Product Change Notification

MultiConnect[®] rCell 100 Series Cellular Routers

MTR-LEU7 Models Updated Cellular Radio Firmware

Product Change Notification (PCN) Number
PCN 12072021-001 (MTR-LEU7)

III. Cellular Radio Firmware Release Notes

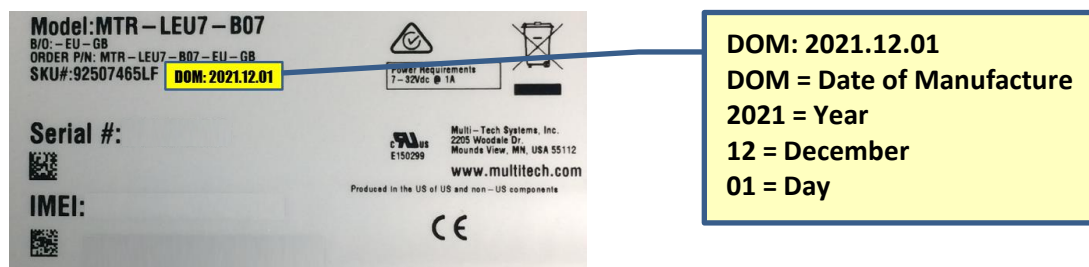
The document below provides the release notes for EG95-E-FB firmware version **EG95EFBR06A07M4G 01.001.01.001**. It describes major changes compared to EG95-E-FB firmware version **EG95EFBR06A06M4G 01.005.01.005**. For a detailed listing of all changes, refer to the EG9X AT Command Set.

New cellular radio firmware version: **EG95EFBR06A07M4G 01.001.01.001**

3. Product Packaging

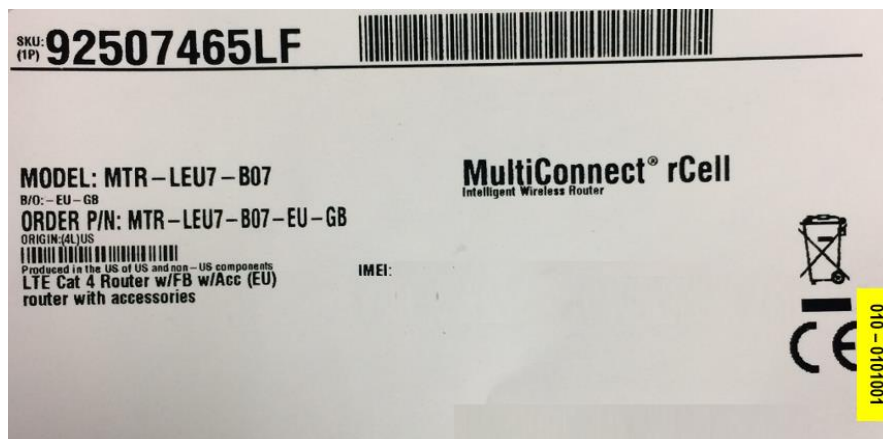
The carton label for each MTR includes the version of cellular radio firmware included.

010 – 0101001	EG95EFBR06A07M4G 01.001.01.001	Current Firmware Shipping in December 2021
010 – 0501005	EG95EFBR06A06M4G 01.005.01.005	Original Firmware Shipping in February 2020
